Subject: Inspecting the bearing brackets and the toggle force of the airbrake control circuit.

Serial number applicability: Glider ASK 13, Data Sheet no.267.
A) Serial no.s 13000 thru 13689 including;
B) All serial no.s.

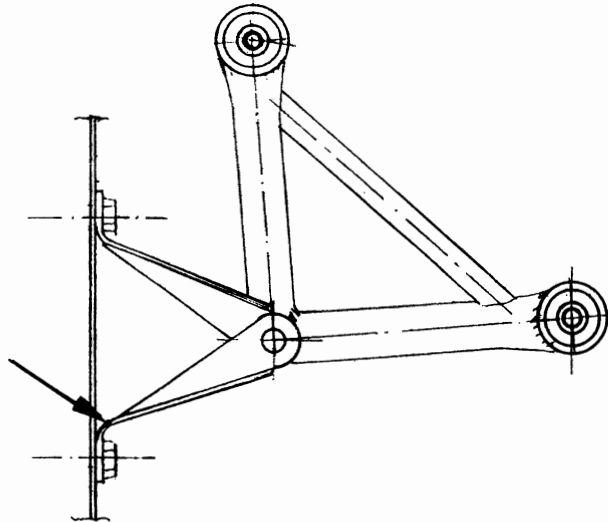
Reason: On some gliders of the model ASK 13 the bearing brackets of the airbrake control circuit have broken at the wing root rib. The failure was caused by too high toggle forces which resulted from a wrong adjustment of the toggle in the airbrake control circuit.

1. Carefully inspect the bearing brackets of the airbrake control circuit at the wing root ribs as well as the root ribs themselves for damage, cracks etc. In case of doubt the paint must be removed off the bracket. In most cases the breaks were found at the bottom of the front bearing bracket; refer to the drawing on Sheet 2 of this TN !
Where damages at one bearing bracket are found, this part must be exchanged; where a root rib is damaged, it requires repair.

2. Check the toggle force as described under Point 3.) and where necessary adjust.
3. Adjustment Instructions For Airbrake Toggle
 - 3.1 Undo the airbrake return spring at the front operating lever in the cockpit.

- 3.2 The airbrake toggle - each side separately - must be adjusted such that a force of approx. 3 to 4 daN is obtained at the front airbrake operating lever when measured from above (measurement distance from the pivot point of the operating lever towards the hand grip = 300 mm).

- 3.3 Adjustment of the toggle force is done by turning in or out the adjusting heads in the fuselage. If the correct adjustment values cannot be achieved here, the thickness of the airbrake stop blocks inside the wings must either be increased or cut back.

- 3.4 Take care that the toggle must not go over the dead point which would cause the airbrakes to extend again.
- 3.5 For both airbrakes together, the hand forces must not exceed approx. 6 daN, when measured at the front airbrake operating lever from above.
- 3.6 Re-fit the airbrake return spring at the front operating lever in the cockpit.
4. This Technical Note must be inserted as appendix into the ASK 13 Flight and Maintenance Manual and this action must be entered into the "Amendments" on page 2.
5. The inspection of the bearing brackets and of the toggle force of the airbrake control circuit (as described under points 1. thru 3.) must be included from now on within each annual C. of A. inspection.
